UNITED STATES PATENT AND TRADEMARK OFFICE

APPLICATION NO.	FILING DATE	FIRST NAMED INVENTOR	ATTORNEY DOCKET NO.	CONFIRMATION NO.
10/780,999	02/18/2004	John A. Johansen	2065.002300	2417
23720	7590	06/06/2005	EXAMINER	
WILLIAMS, MORGAN & AMERSON, P.C. 10333 RICHMOND, SUITE 1100 HOUSTON, TX 77042			WAKS, JOSEPH	
			ART UNIT	PAPER NUMBER
			2834

Office Action Summary	Application No. 10/780,999	Applicant(s) JOHANSEN ET AL.	
	Examiner Joseph Waks	Art Unit 2834

FIG. 1

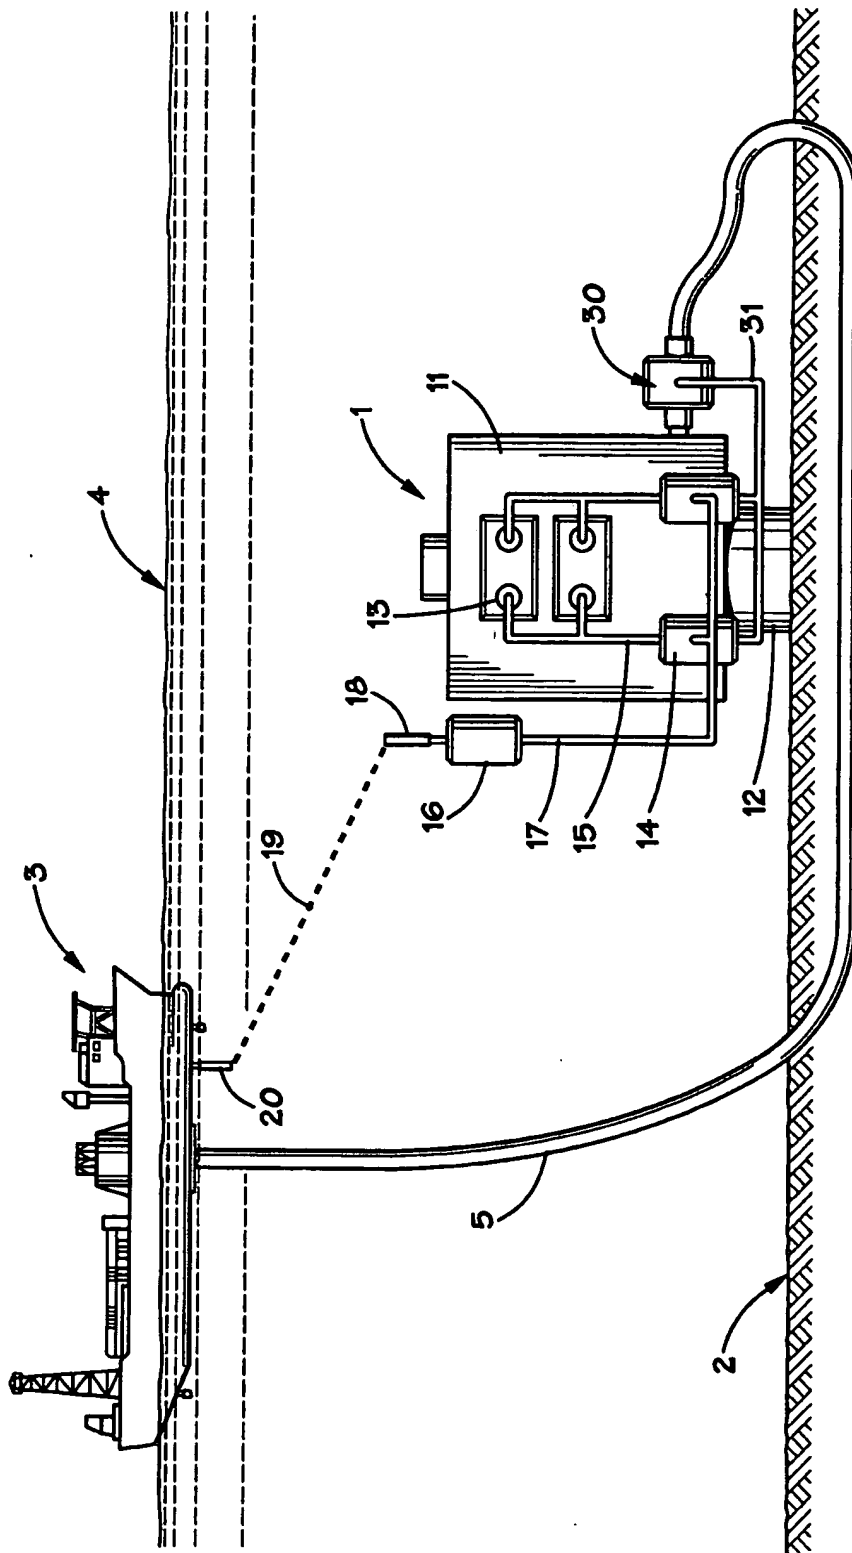
Not approved
JW 5/25/05

FIG. 2

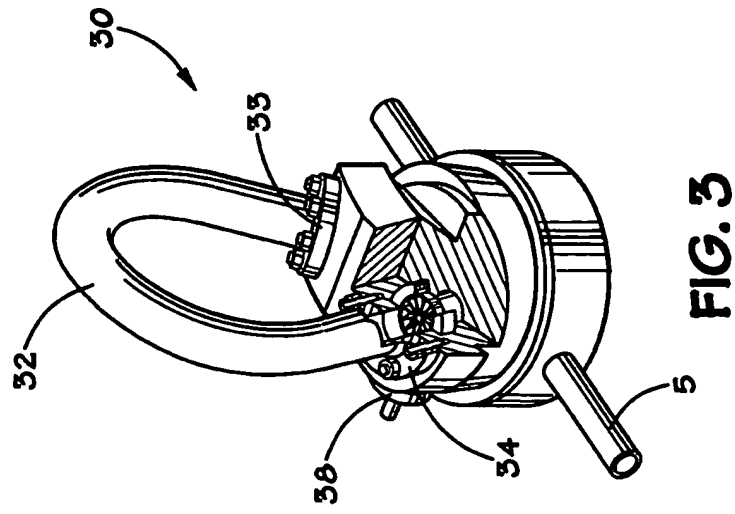
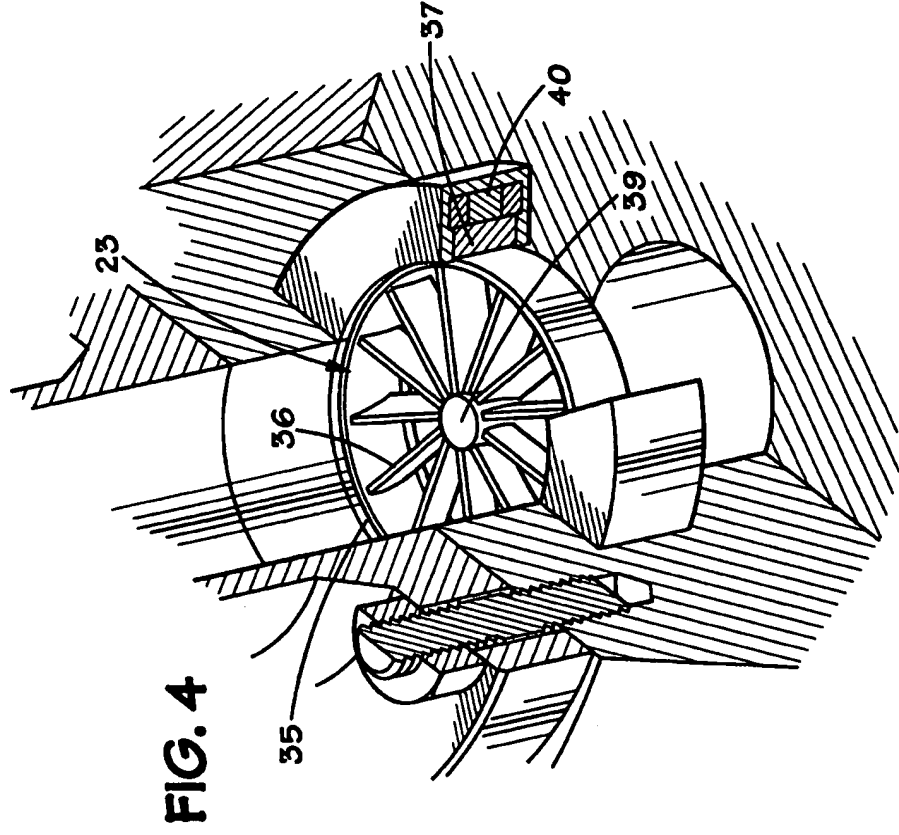
Not approved
5/25/05 Jw

Not approved
5/25/05 JW
